Staff Report

To: Salt Lake City Planning Commission
From: Alicia Seeley, Principal Planner
Alicia.Seeley@slc.gov, 801.535.7922
Date: September 9th, 2026
Re: PLNPCM2026-00568, Silo Park Retail Design Review

Design Review

North Elevation with spandrel glass

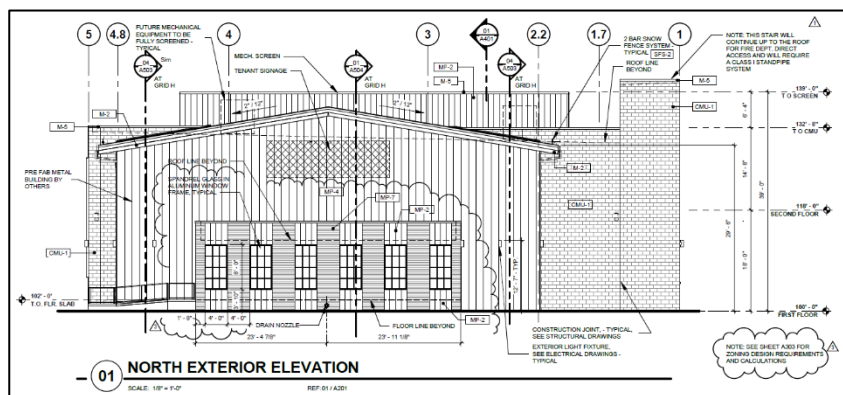
The applicant is also requesting relief from the minimum required ground floor glass per section [21A.37.050.C.1](#). The MU-11 zone requires a minimum of 60% glass, as calculated between three feet and eight feet from the finished first floor. The ground floor glass shall also allow unhampered and unobstructed visibility into the building for a depth of at least five feet. The applicant is requesting relief from this provision on both the north and east facades of the building, on which they intend to provide 32% and 31% of ground floor glass, respectively. Relief is requested to accommodate the unique internal uses, described in more detail below:

The northernmost area of the building is intended to be used as a greenroom. Artists will use this space as an area to stage equipment, change clothes, and otherwise prepare for performances. The area above the green room is designed to serve as the backdrop to the music venue. Views into this portion of the building would compromise

the privacy and therefore the functional use of the space. To break up the façade and add some visual interest, the applicant is proposing 32% of the ground floor façade as spandrel glass, which is not a reflective surface, but also does not provide unobstructed visibility into the building. As the building will be highly visible from pedestrians on all sides, the green room and venue backdrop are located on the side of the building away from the intended pedestrian corridors and gathering spaces, which is consistent with the intent of this provision.

A110
SITE PLAN

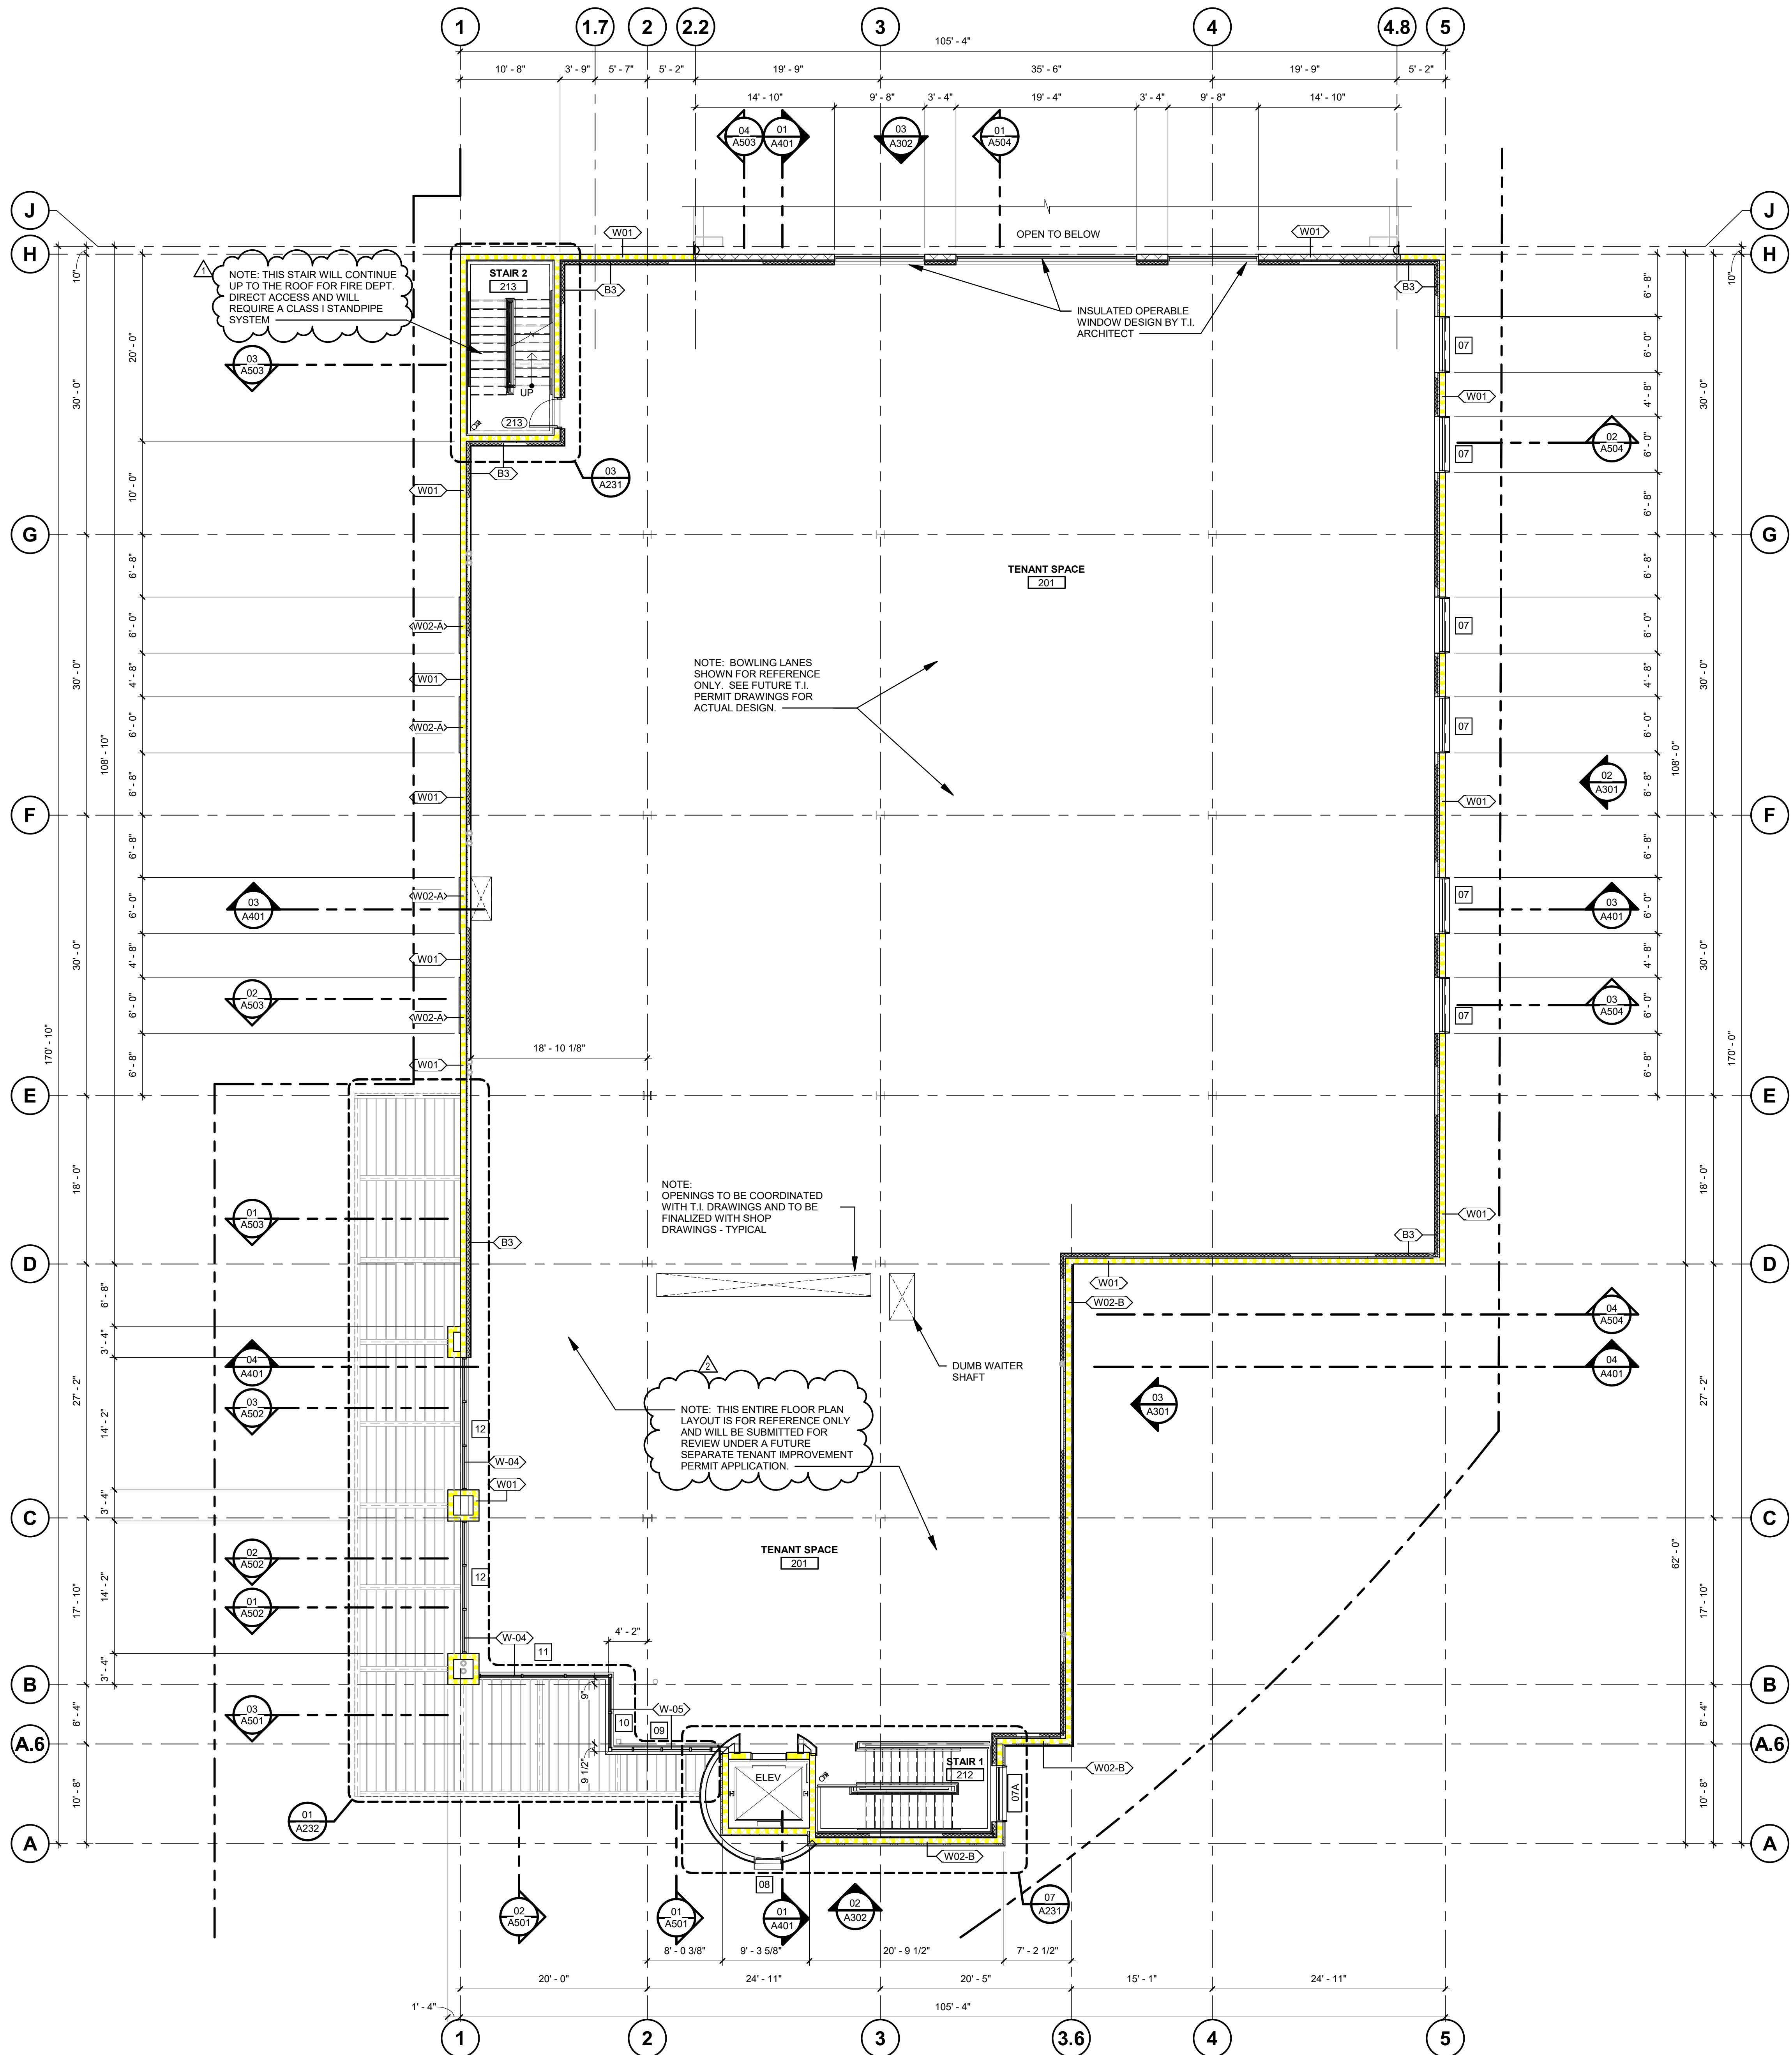
Sidewalk Width: Transportation does not recommend a reduction in the required sidewalk width from 10' to 8'. A future Trax light rail line is currently being planned on 400 West. Plans for the rail line are being designed to accommodate the City's preferred 10' wide sidewalk within the future street cross section. Sidewalk should be widened toward the property line on both 400 West and 500 South to prevent narrowing of the existing park strip.

Design Comment: Plans show two drive approaches on 400 West and one on 500 South that do not meet City requirements. Drive approaches that do not lead to legal parking or loading must be removed and replaced with curb and gutter. The south drive approach on 400 West leads to a service area. Since there is no room on site for maneuvering vehicles this drive approach will require vehicles accessing the site to back into or from the road and across the sidewalk. With the completion of the Silos development, adjacent developments, and the proposed Trax line, pedestrian and bicycle activity is likely to increase. Any design that does not provide for forward access into and from the property should not be permitted.

**The applicant since updated plans and Jena has confirmed that Transportation's requirements are met

02 EAST EXTERIOR ELEVATION

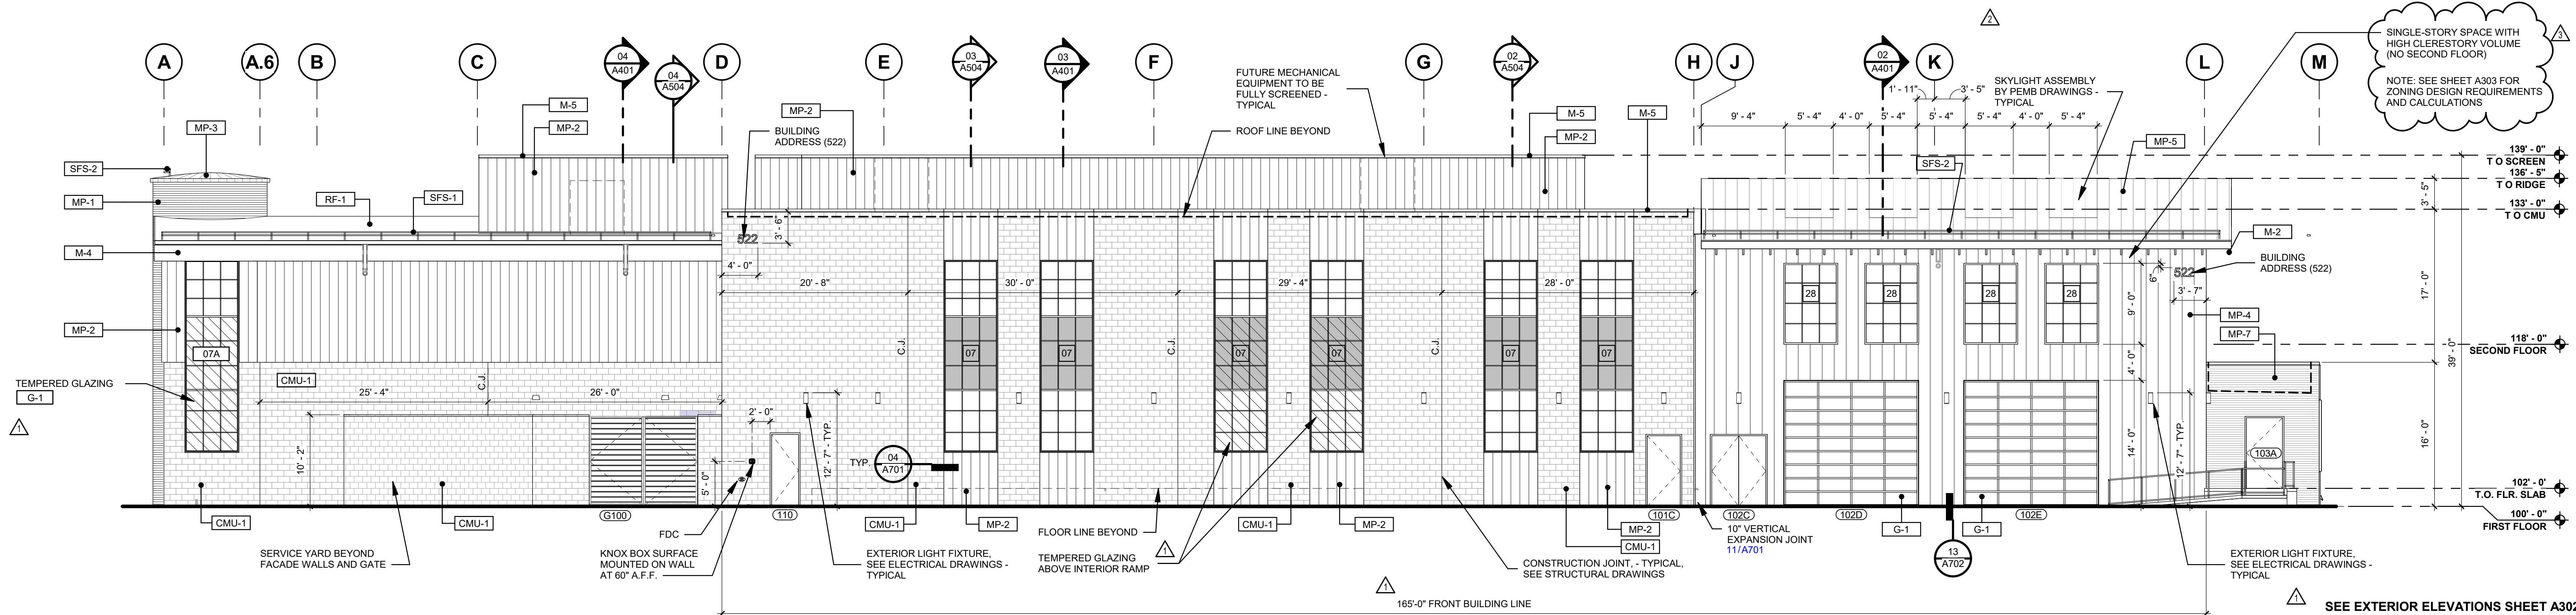
The proposed design includes 31% of ground floor glass on the east façade. The reduction in glass is requested to accommodate the interior music venue and open dining space. A clear span on the north portion of the building is needed to create the open concept and avoid adding columns that would obstruct patrons' views of performances. The two-story volume also requires shear and structural strength on the west and east walls to support the bowling venue above the first-floor dining area. The structural support needed for these uses limits the amount of glass that can be feasibly added to the east façade. In order to meet the intent of this standard while being sensitive to the intended use, the applicant proposes concentrating the ground floor windows and public interest along the southwest portion of the building, which will function as the main entrance oriented toward the public gathering spaces. This portion of the building will provide 66% of ground floor glass. The setback portion of the building on the south side will be used to screen mechanical equipment. The interior portion of this space will also support equipment for sound and light, making windows a challenge. Although this section will be somewhat visible from 400 W, it will be mostly obscured by the Rimini Coffee building's curved shape to the south. To further

add pedestrian interest, the applicant intends for this space to be tenant signage or to provide a painting pattern, similar to that which was provided across the street at the Traeger Grills building.
